Device **XC886CM-8FF**
Marking/Step **EES AA**
Package **PG-TQFP-48**

This Errata Sheet describes the deviations from the current user documentation.

INT_XC8.004 Unable to Detect New Interrupt Request if Any One of Timer 2/Timer 21/UART1 Interrupt Flags Is Not Cleared (Unexpectedly)

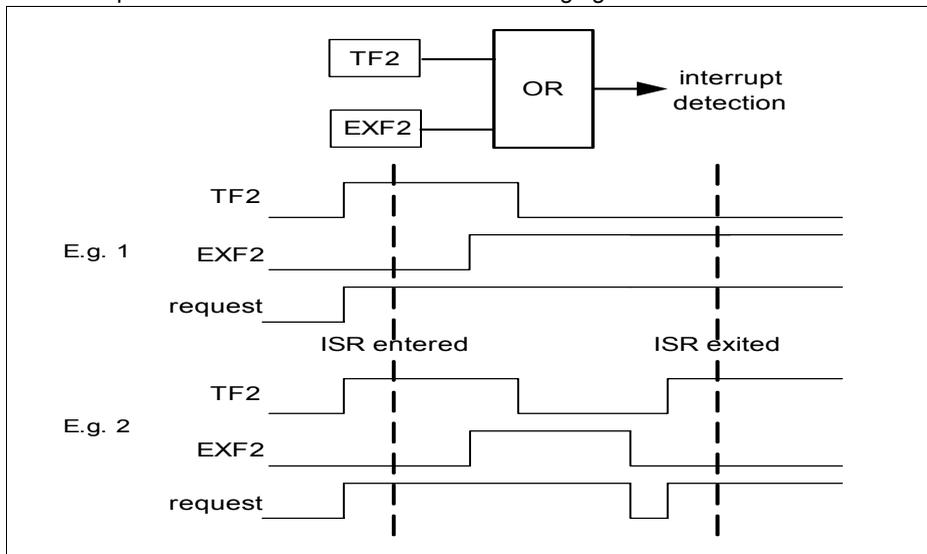
As illustrated in the simplified figure, the Timer 2 interrupt flags TF2 and EXF2 are combined as one interrupt request output. These flags are located within the Timer 2 kernel, with a single interrupt request line as output from the kernel.

Being of interrupt structure 2, the interrupt request of Timer 2 is detected on the rising edge of a positive pulse.

The problem is that it may occur at some point in the application, that any new Timer 2 interrupt request can no longer be detected after a return-from-interrupt (reti) due to service of earlier event(s). This happens when the following conditions are true:

1. Timer 2 events are serviced by interrupt (i.e. flags are checked and cleared only in the interrupt routine ISR),
2. Either TF2 or EXF2 is set at any one time throughout the ISR (even while the other is cleared) such that at least one of the flags is still set after reti, causing the Timer 2 request line, which is an OR-function of the two flags TF2 and EXF2, to remain set throughout the ISR and after reti.

This means, any future Timer 2 TF2 or EXF2 event is not able to cause a rising edge and therefore not able to trigger an interrupt request to the core – as if the Timer 2 interrupts had been disabled, until both EXF2 and TF2 flags are cleared at some time. The clearing of flags would have to be done by user’s code additionally outside of the Timer 2 interrupt routine, which is however normally not feasible with an interrupt service scheme.

There is no problem if EXF2 is not enabled by setting bit EXEN2 = 0 i.e. external events are disabled, or if bit DCEN = 1 in auto-reload mode.

Otherwise if EXF2 is enabled, while TF2 is always enabled when Timer 2 is running, there are two suggested workaround:

1. If other events of Timer 2 interrupt node (ET2) need not be enabled for interrupt, disable this interrupt node and use software polling of the flags instead.
2. Before return from interrupt, check again if TF2 or EXF2 is (still) set (due to new request since the last check). If so, jump and execute the ISR routine from start. Exit only when all flags are checked to be cleared. However, dummy interrupt of the node may occur after return from interrupt, and should be ignored. Another drawback is if Timer 2 events are occurring at high rate, the CPU may be 'stuck' in the service routine of the Timer 2 interrupt for a long time.

INT_XC8.H004 NMI Interrupt Request With No NMI Flag Set

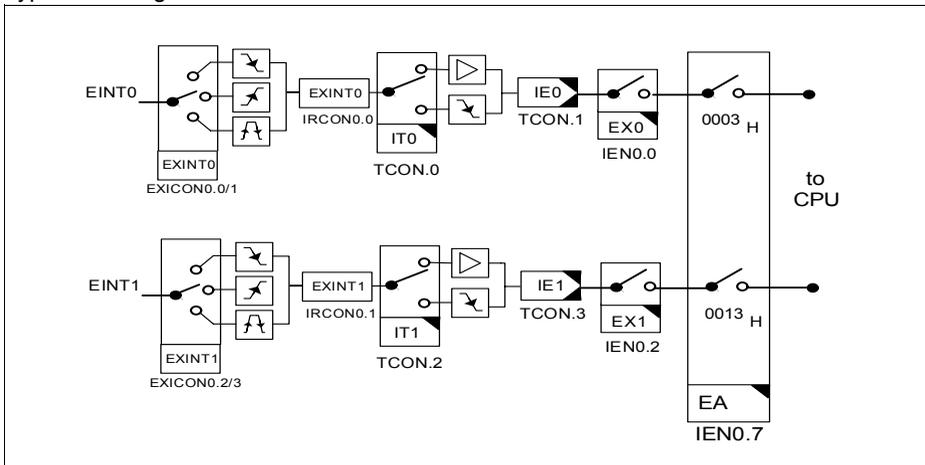
Consider the following NMI interrupt service routine pseudo-code, and scenerio where a NMI interrupt source A event leads to interrupt request of the NMI node and CPU vectors to the NMI interrupt routine. Meanwhile, NMI interrupt source B and its flag becomes active any time in the duration indicated by T:

In this case, NMI flag B will be cleared as a standard procedure by the NMI interrupt routine in the current service. However, the pending interrupt request for the NMI node remains activated after RETI, as it is only cleared by hardware when CPU acknowledge the NMI interrupt and vectors to the NMI service routine.

This leads to following servicing of the NMI interrupt node again, but potentially no active NMI flag is found, i.e. dummy NMI interrupt service. The point to note is that the NMI interrupt source B is not lost, as it was actually serviced in the current service of the NMI interrupt node.

The recommendation is to ignore these dummy NMI interrupt vectoring.

INT_XC8.H003 Interrupt Flags of External Interrupt 0 and 1

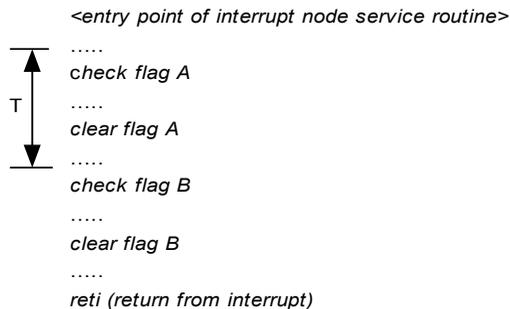
Besides the above notes, the following should be noted on the behavior regarding setting and clearing of the external interrupt x (x = 0 or 1) flags, applicable to both edge and bypass edge detection modes:

1. The flag TCON.IEx will be set in all modes selectable via EXICON0 register.
2. Flag IRCON0.EXINTx will be set in all modes as long as an active edge is detected; flag EXINTx will not be set for low level as active event.

1. Flag IEx is cleared automatically by hardware when the interrupt is being vectored to.

2. Flag EXINTx has to be cleared by software.
3. Clearing one external interrupt x flag will not clear the other. Especially, clearing flag EXINTx will not clear the flag IEx. Being of interrupt structure 1, the flag IEx is the request polled by the CPU for interrupt servicing. Therefore user has to take care to clear the flag IEx before switching from SW polling method to enabling the external interrupt x node, to prevent potential dummy interrupt request.
4. Always clear both EXINTx and IEx flags before (if) changing the trigger select in EXICON0 register.

INT_XC8.H005 Not all Flags are qualified for clearing Pending Interrupt Request

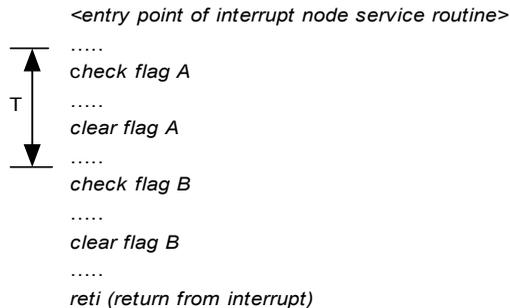
Consider the case where an enabled interrupt node is shared by more than 2 events, and where at least two of the events (A and B) are enabled for interrupt while at least one event (C) is not enabled for interrupt. In this case, flag C is one of the flags listed in above table.

While the interrupt routine is already running due to event A having occurred, event B and C occurs any time in the duration indicated by T:

This sets the pending interrupt request while flag B is set.

Although event B is serviced and flag B is cleared in the following service routine, on return from interrupt, the pending interrupt request remains activated. This is because event C is not enabled for interrupt (and therefore flag C is neither checked nor cleared in the interrupt routine) while flag C is not qualified.

This leads to following servicing of the interrupt node again, but potentially no active flag is found, i.e. dummy interrupt service.

To prevent such dummy interrupt vectoring on the above listed interrupt nodes, do not use mixed interrupt servicing and polling scheme, i.e, enable all events of the node for interrupt if interrupt node is enabled.

Otherwise if mixed interrupt servicing and polling scheme is to be used, ignore these dummy interrupt vectoring.
